DEPARTMENT OF CITY PLANNING

RECOMMENDATION REPORT

Case No.: CPC-2021-2020-DB-CDP-SPPC-MEL-HCA
CEQA No.: ENV-2021-2021-CE
Council No.: 11 – Park
Plan Area: Venice
Specific Plan: Venice Coastal Zone Specific Plan - North Venice Subarea
Certified NC: Venice
GPLU: Neighborhood Office Commercial
Zone: C2-1-O

PROJECT LOCATION: 1410 – 1422 South Main Street

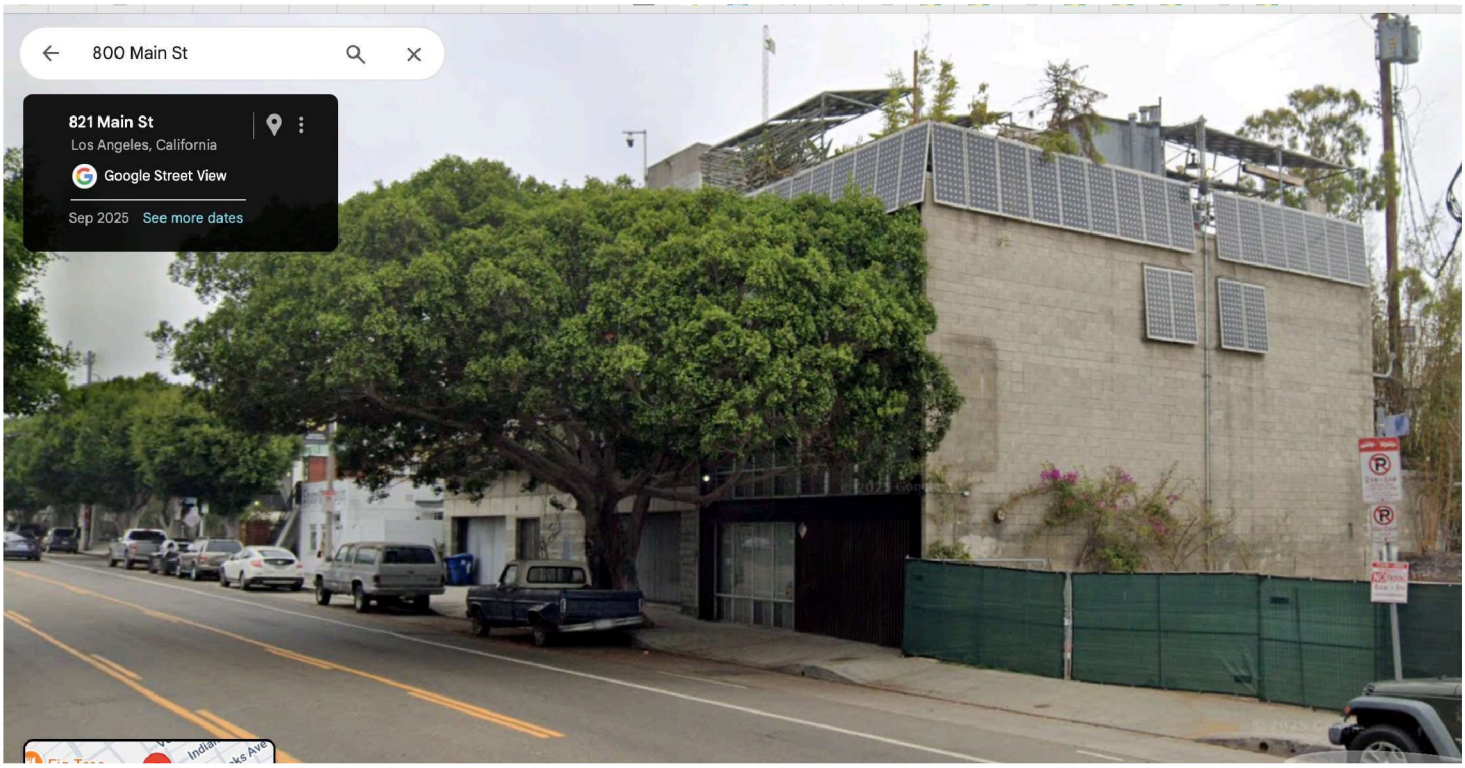
This is an ugly solar canopy at 800 Main in Venice and this is not 15 ft high.
